SAFETY EVALUATION REPORT
RETURN TO SERVICE PLAN - SEISMIC REEVALUATION PROGRAM
SAN ONOFRE NUCLEAR GENERATING STATION, UNIT NO. 1

Fig. 1

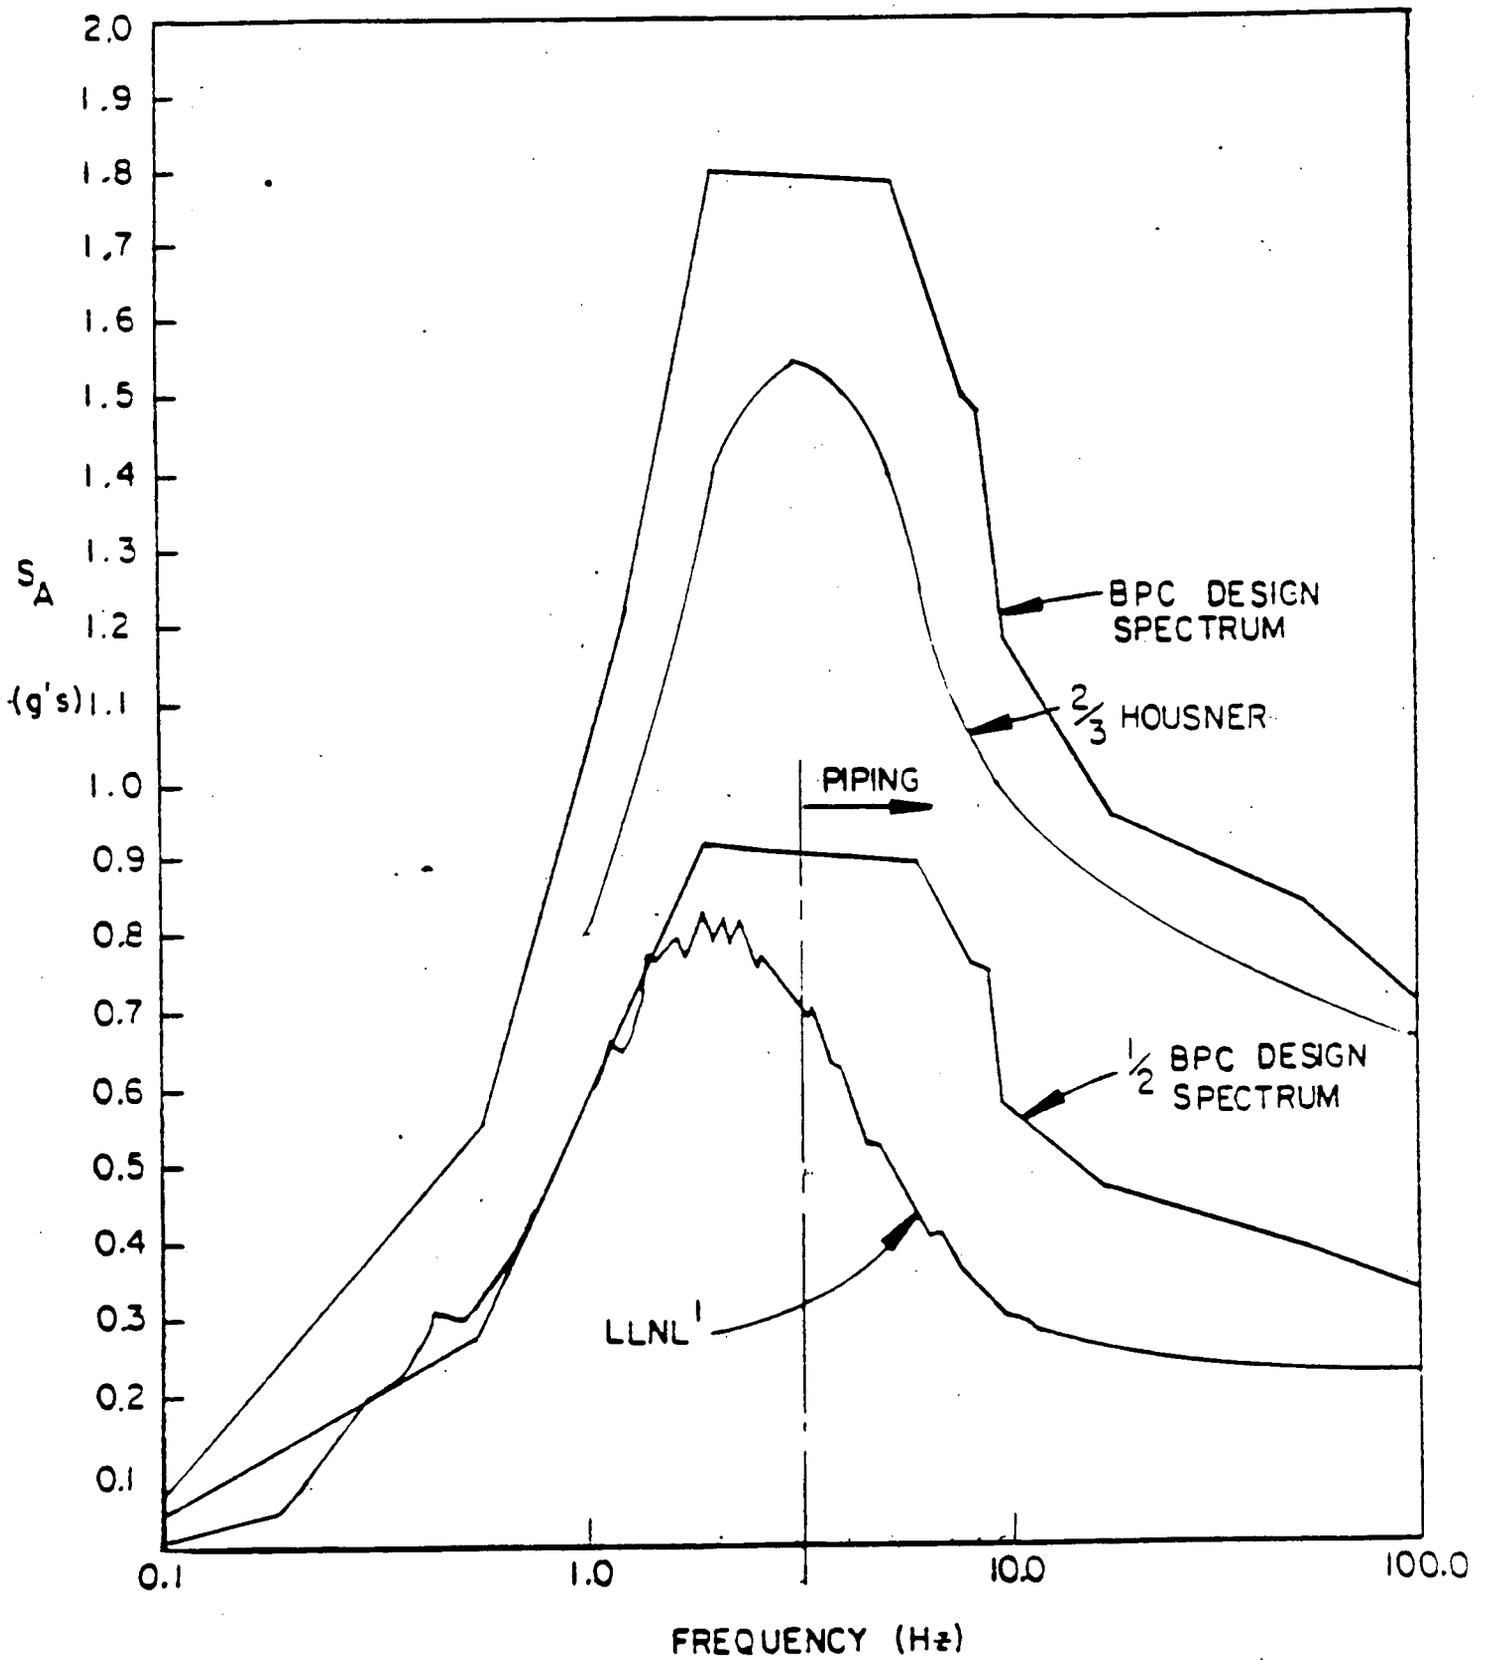
In order to account for the effects of embedment, the licensee has proposed to apply a modified floor response spectra for the evaluation of components inside the containment. The licensee developed a revised floor response spectra, as shown in Figure 1, based on analyses and modelling performed by the Lawrence Livermore National Laboratory (LLNL) for the NRC. ² LLNL analyzed the San Onofre Unit 1 auxiliary feedwater system as part of a generic research project.

The staff agrees that a reduction factor may be appropriate to account for embedment effects as shown by the previous earthquake recordings. However, the staff has found that modelling techniques and analysis methods used in the LLNL analyses significantly overestimate that effect. Those analyses were performed with the CLASSI computer code assuming vertically propagating seismic waves. This approach is equivalent to a "deconvolution" technique and results in an input ground motion for the analysis of the containment building which can be a factor of two to three lower than the free-field ground motion. Extensive peer reviews of deconvolution^{3/} techniques have found that these techniques could be unrealistic.

The staff has previously provided guidance on soil-structure interaction review which allows a reduction factor of up to 25% to the free field ground motion when applied for the structural analyses, depending on the nature of the earthquake records used to define the site-specific ground motion and local site conditions.^{4/} The reduction factor can be derived from an analysis of the earthquake data used for the development of design basis earthquake ground motion at the site. The specific reduction factor allowed depends upon the extent to which surface measurements were used, the extent to which the site conditions match those where the strong motion data were recorded and the extent to which the site conditions justify such a reduction.

The resulting reduction factor would then be applied to calculated floor response spectra using the site-specific ground motion as an input at the foundation, provided that the floor response spectra are generated using linear-elastic, dynamic structural analyses.

Fig. 2

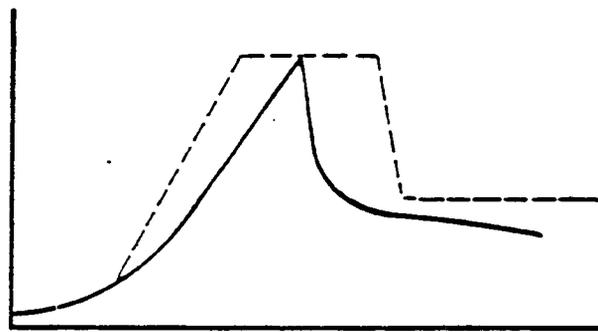
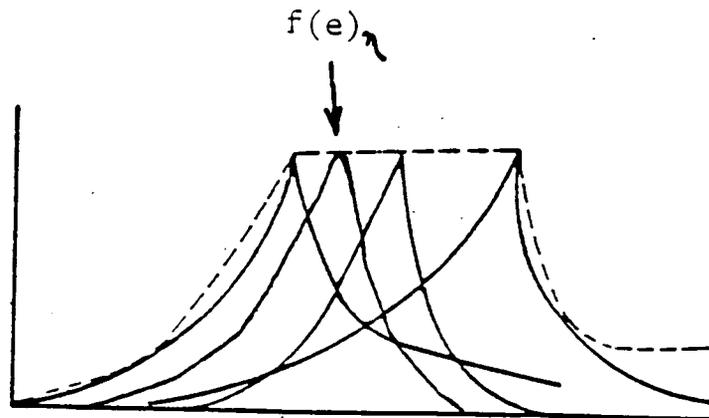
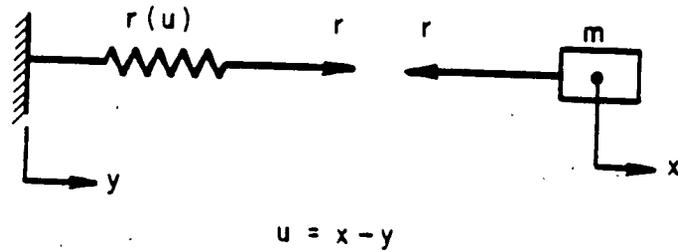
Regulatory Guide 1.122 recommends that the calculated dominant peaks of the floor response spectra be broadened to account for uncertainties in the structural frequencies owing to uncertainties in the material properties of the structure and soil and to approximations in the modeling techniques. The licensee has proposed to use a spectral peak shifting method, as depicted in Figure 2, where the licensee judges that overstressing is caused by the additional energy associated with the broadened peak.

- (a) This method is less efficient for independent multiple-support motion; i.e., different motion at different supports in a system. If such a situation arises in the evaluation of San Onofre Unit 1, the staff will require that the licensee justify the application of any spectral shifting and demonstrate the statistical significance on a case-by-case basis before restart.

- (b) The specific method proposed by the licensee is based on a single spectral peak within a defined frequency range of interest. ^{5/} However, in some cases there is more than one "dominant" peak within this range. Therefore, the staff will require that the licensee justify the application of this technique on a case-by-case basis before restart for those cases in which there is more than one "dominant" peak. For the long-term, the staff will review the application of this technique to assure that there are no other instances of multiple dominant peaks.

The staff considers the proposed method more realistic and, therefore, acceptable for both restart and long-term, with two exceptions:

FIG. 3 RESISTANCE - DISPLACEMENT RELATIONSHIP
(From NUREG/CR-0098)

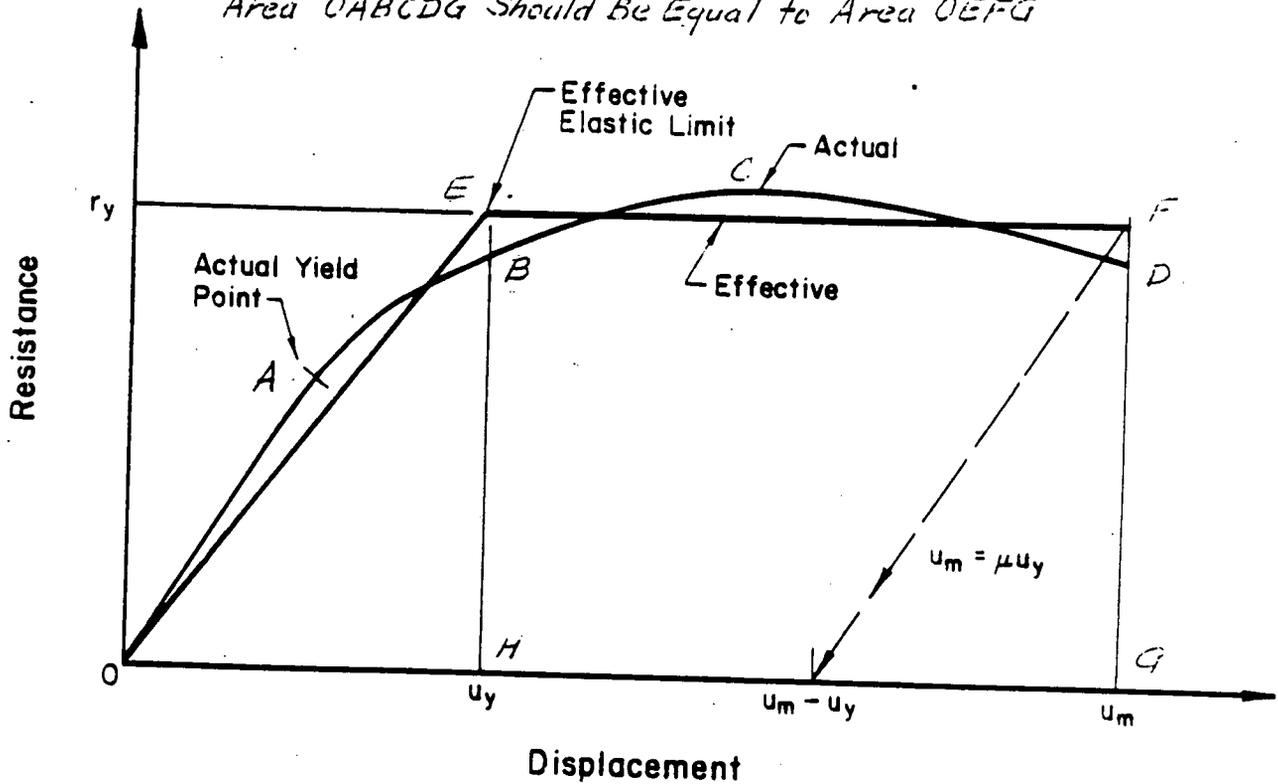
The staff has found that the approach proposed by the licensee appears to overestimate the yield displacement of structural elements in the basic definition of the ductility ratio. Moreover, the licensee did not adequately define the method of application for the proposed criteria.

The ductility factor is the ratio of the calculated displacement of a member 8 to the "effective" elastic limit displacement, as shown in Figure 3. The highly non-linear load (i.e. resistance) displacement relationship is approximated with an "effective" load-displacement curve of equal area, which projects the effective elastic limit. An analogous relationship exists for bending moments if the yield moments and displacements are used, as depicted in Figure 4; however, the licensee has proposed to use the plastic moment capacity instead of yield displacement to define the ductility ratio. In addition, the staff noted the following issues during the review of these proposed criteria:

- (a) Because the relationship between the ratio of moments (M/M_y) and the ratio of displacements (δ/δ_y) is not defined, it is not clear why M/M_y is used to calculate the ductility ratio, instead of the displacement ratio.

- (b) The licensee did not justify the relationship
$$(2\mu - 1)^{\frac{1}{2}} = P/P_y + M_x/M_{px} + M_y/M_{py}$$
- (c) The general relationship $(2\mu - 1)^{\frac{1}{2}} = \delta/\delta_y$ or θ/θ_y is valid roughly in the range of 2-8Hz. It is not clear what relationships would be used outside this range.

The concept of the use of ductility ratio, as a measure of the degree to which a structural member can go into the inelastic range and still retain its function, is acceptable to the staff for both restart and long-term operation. However, the staff does not agree that the calculational method proposed by the licensee is acceptable. The staff concludes that a ductility ratio calculated based on the yield displacement instead of the plastic moment capacity of the beam is acceptable; other calculational techniques may be acceptable if the licensee can justify the method of application prior to restart.
